Access Compliance Report

Intersection ID: 47581	Main Street: ROCK_ISLAND_RD	Cross Street: GLENBURN_LN	Location: NE
ADA ID: A46577EBA475	Ramp Type: PerpDiag	Initial Pass/Fail: Fail	Overall Compliance: No
Codes/Mitigation Info/Possible Solution			Severity Score: 25
			Field Measurements/Component Compliance

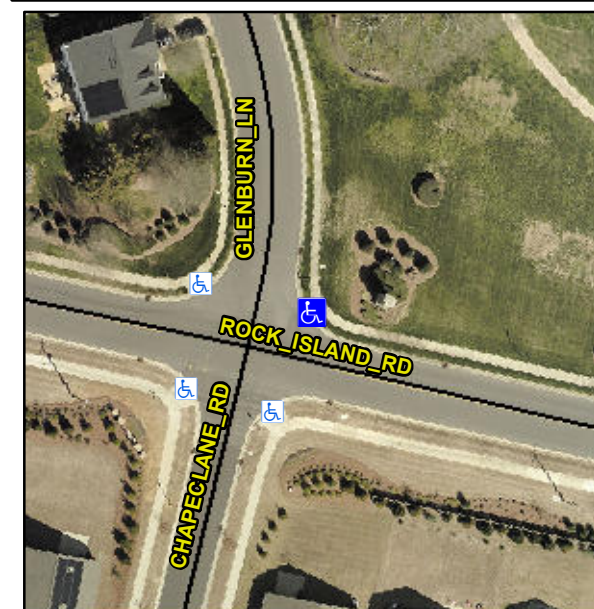
Not Found, R304.2.2, R304.5.3

Compliance	Description	Data	Compliance	Description	Data
N/A	Ramp Length (in)	49.0	No	Ramp Slope (%)	8.8
Yes	Ramp Width (in)	48.0	No	Ramp XSlope (%)	5.7
N/A	Flare Type LT	N/A	N/A	Flare Type RT	N/A
N/A	Flare Slope LT (%)	N/A	N/A	Flare Slope RT (%)	N/A
N/A	Flare Traversable LT?	N/A	N/A	Flare Traversable RT?	N/A
N/A	Landing Length (in)	N/A	N/A	DWS Provided?	N/A
N/A	Landing Width (in)	N/A	N/A	DWS Contrast?	N/A
N/A	Landing Slope (%)	N/A	N/A	DWS Length (in)	N/A
N/A	Landing X Slope (%)	N/A	N/A	DWS Full Width?	N/A
N/A	Landing Curb? (Y/N)	N/A	N/A	DWS Offset (in)	N/A
N/A	Shared Landing?	N/A			
N/A	Gutter Ponding?	N/A	N/A	Gutter Slope (%)	N/A
N/A	Gutter Lip Ht (in)	N/A	N/A	Gutter X Slope (%)	N/A
N/A	Painted X Walk1?	No	N/A	Painted X Walk2?	No
	X Walk 1 Direction	To NW		X Walk 2 Direction	To SW
N/A	X Walk 1 Width (in)	N/A	N/A	X Walk 2 Width (in)	N/A
	X Walk 1 Slope (%)	2.9		X Walk 2 Slope (%)	2.4
	X Walk 1 X Slope (%)	2.6		X Walk 2 X Slope (%)	2.4

Remove & Replace Curb Ramp With Two New Directional Ramps or Equivalent.
